Project	IEEE 802.16 Broadband Wireless Access Working Group < http://ieee802.org/16 >	
Title	H-ARQ support corrections, for OFDMA PHY mode	
Date Submitted	2004-04-22	
Source(s)	<p>Panyuh Joo, Seungjoo Maeng, Jaeho Jeon, panyuh@samsung.com Soonyoung Yoon, Jeong-Heon Kim, Jaehyok Lee, Myungkwang Byun, Inseok Hwang, yigall@runcom.co.il Jaehee Cho, Jiho Jang, Sanghoon Sung, Samsung Electronics Co. Ltd. lim@etri.re.kr</p> <p>Yigal Leiba, Zion Hadad, Yossi Segal, Itzik Kitroser Runcom Technologies</p> <p>Choongil Yeh, Hyuongsso Lim, Yuro Lee, Jongee Oh, DongSeung Kwon, ETRI</p>	
Re:	Sponsor re-circulation Ballot	
Abstract	H-ARQ support corrections, for OFDMA PHY mode	
Purpose	Adoption of proposed changes into P802.16-REVd/D4-2004	
Notice	This document has been prepared to assist IEEE 802.16. It is offered as a basis for discussion and is not binding on the contributing individual(s) or organization(s). The material in this document is subject to change in form and content after further study. The contributor(s) reserve(s) the right to add, amend or withdraw material contained herein.

In page 529, line 47, correct section 8.4.9.2.3.1 as shown below:

Figure 240—CTC encoder

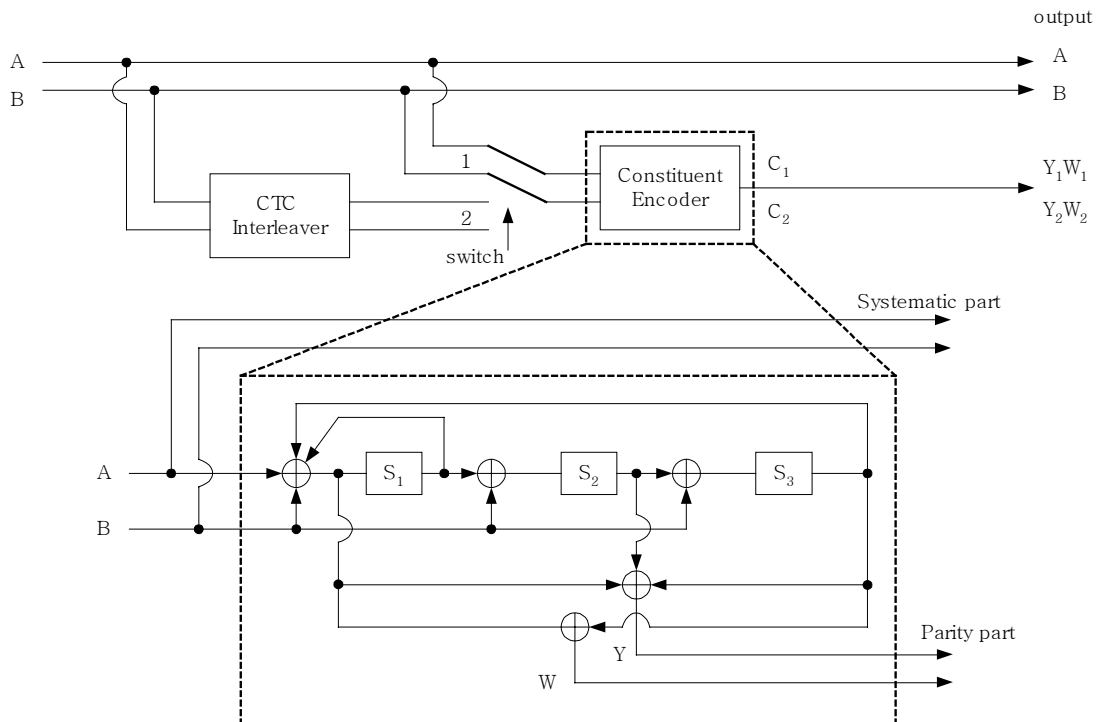
The Convolutional Turbo Code defined in this section is designed to enable support of hybrid ARQ (H-ARQ). H-ARQ implementation is optional. The Convolutional Turbo Code encoder, including its constituent encoder, is depicted in Figure 240. It uses a double binary Circular Recursive Systematic Convolutional code. The bits of the data to be encoded are alternately fed to A and B, starting with the MSB of the first byte being fed to A. The encoder is fed by blocks of k bits or N couples ($k = 2 * N$ bits). For all the frame sizes k is a multiple of 8 and N is a multiple of 4. Further N shall be limited to: $8 \leq N/4 \leq 1024$.

First, the encoder (after initialization by the circulation state Sc_1 , see 8.4.9.2.3.3) is fed the sequence in the natural order (position 1) with the incremental address $i = 0 .. N-1$. This first encoding is called Sc_1 encoding. Then the encoder (after initialization by the circulation state Sc_2 , see 8.4.9.2.3.3) is fed by the interleaved sequence (switch in position 2) with incremental address $j = 0, \dots, N-1$. This second encoding is called C_2 encoding.

The order in which the encoded bit shall be fed into the [interleaver \(8.4.9.3\)](#) [data modulation block \(8.4.9.4.2\)](#) is:

Figure 245—Block diagram of the interleaving scheme

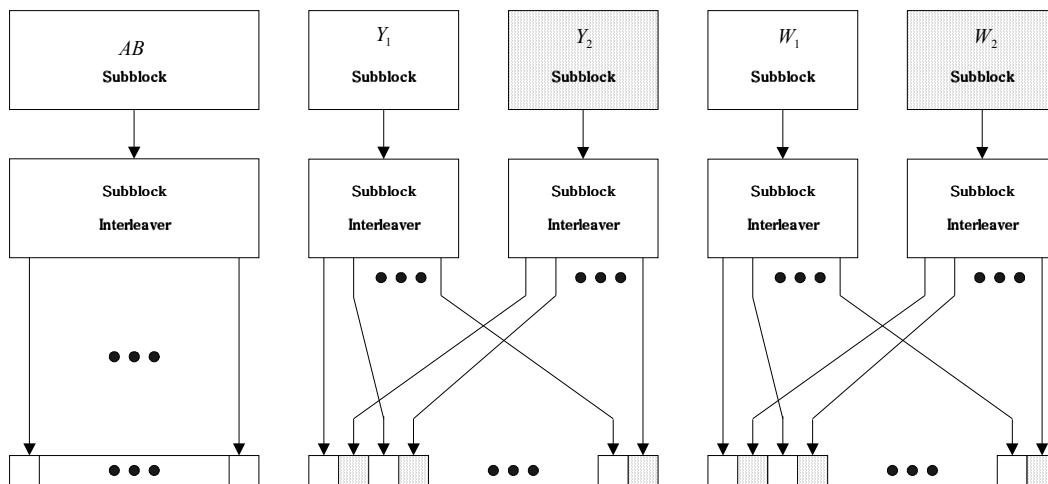
Figure eee245 shows block diagram of the interleaving scheme of the proposed FEC structure. At first, the CTC encoder output is separated into a subblock. Then the interleaving is applied for the bit sequence within the subblock. It guarantees the uniformity of the interleaved codeword. Next, Symbol grouping is performed such that the parity bits from the two constituent encoders are interleaved bit by bit. The systematic part of the 1/2 CTC encoder is located at the head of the interleaved codeword. In this way, the proposed FEC structure ensures the quasi-complementary characteristics of the interleaved codeword and thus, complementary characteristics of the subpacket. We just say “quasi-complementary” for the case of breaking the complementariness of few bits after puncturing.

Figure eee – PRBS of the randomizer

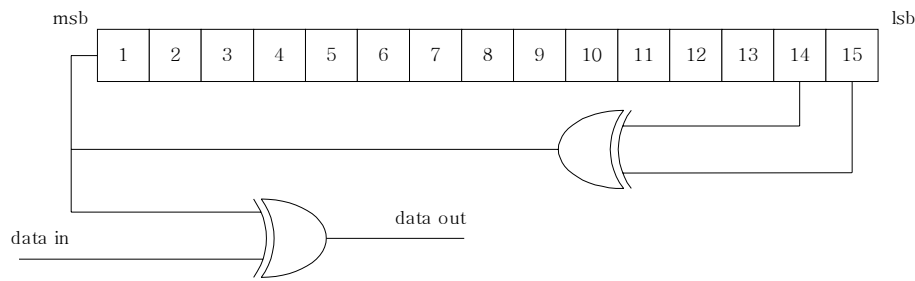
The Pseudo Random Binary Sequence (PRBS) generator shall be $1 + X^{14} + X^{15}$ as shown in Figure eee. Each data byte to be transmitted shall enter sequentially into the randomizer, MSB first. The seed value shall be used to calculate the randomization bits, which are combined in an XOR operation with the serialized bit stream of each burst. The randomizer sequence is applied to the output from the padding block. The bit issued from the randomizer shall be applied to the CRC encoder.

Figure fff – Initialization construction for the PRBS of the randomizer

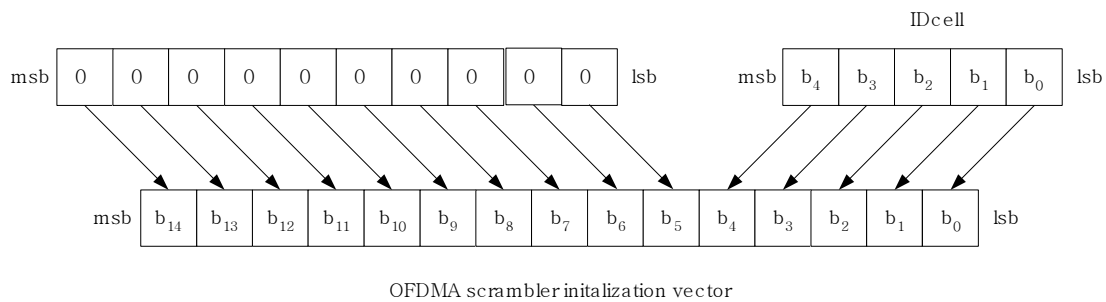
The scrambler is initialized with the vector created as shown in Figure fff. The lowest 5 bits are ID_{cell} or UL_ID_{cell} and the other bits are set '0'.

Figure 125—Construction of H-ARQ encoder packet

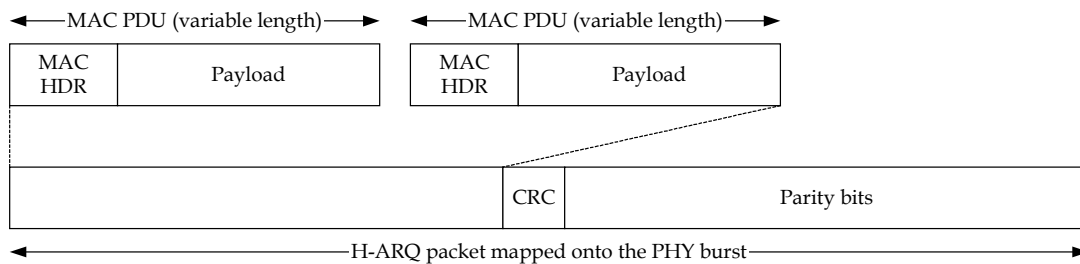
In page 243, line 41, modify the text to read:

One or more MAC PDUs can be concatenated and an H-ARQ packet formed by adding a CRC to the PHY burst. Figure 125 shows how the H-ARQ encoder packet is constructed.

Figure 1 Reduced CID Decoding

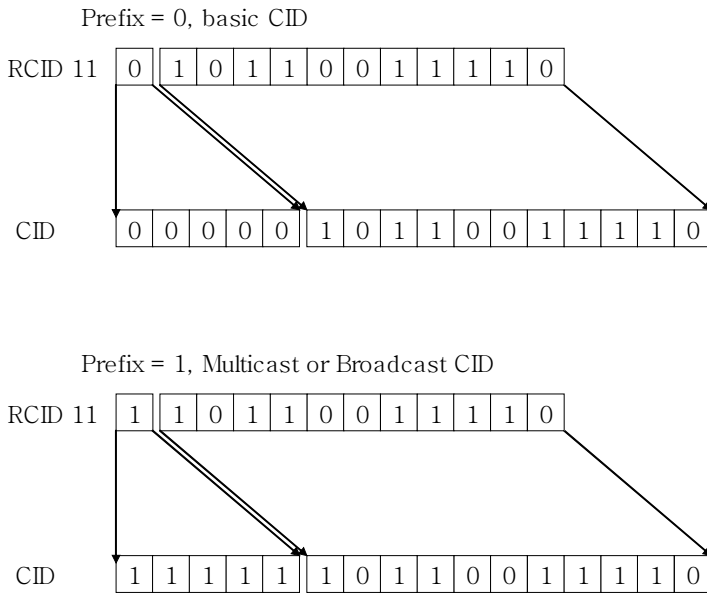
Figure 1 shows the decoding of reduced CID when the RCID_Type is set to 3.

[Figure 2 Subchannel allocation modes of Compact DL-MAP_IE for Band AMC](#)

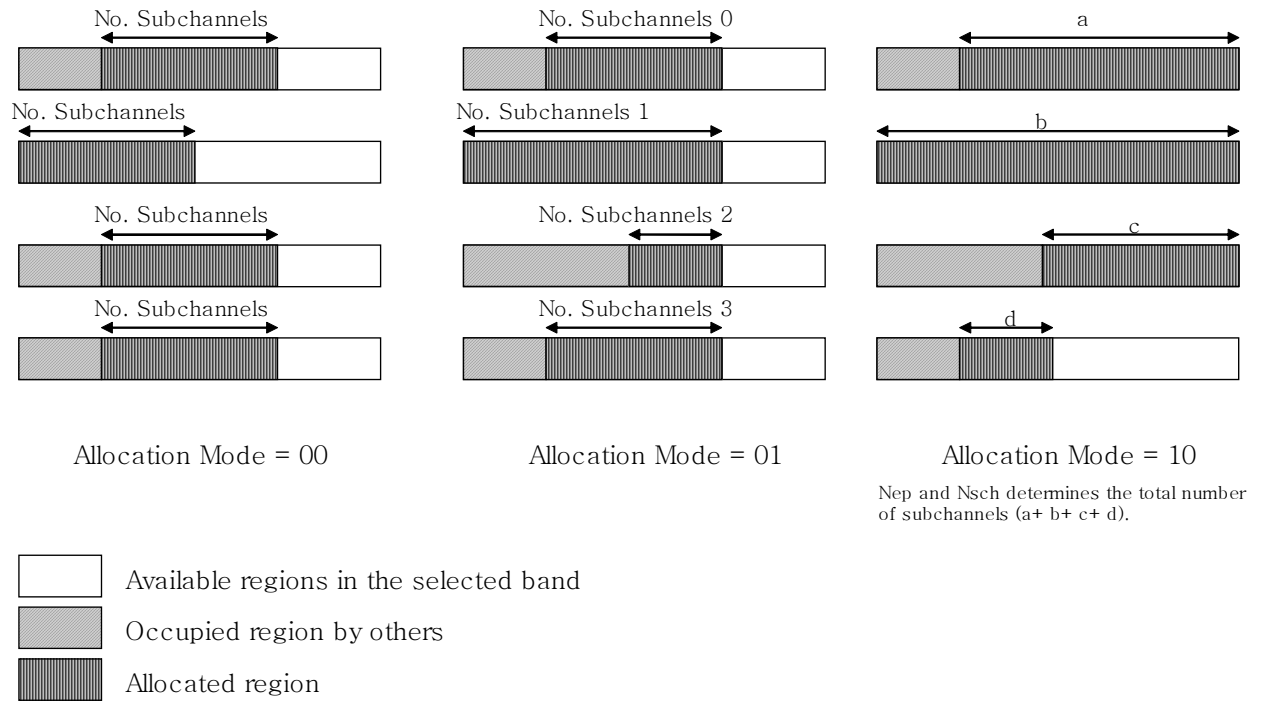
The allocation mode variant is shown in Figure 2.
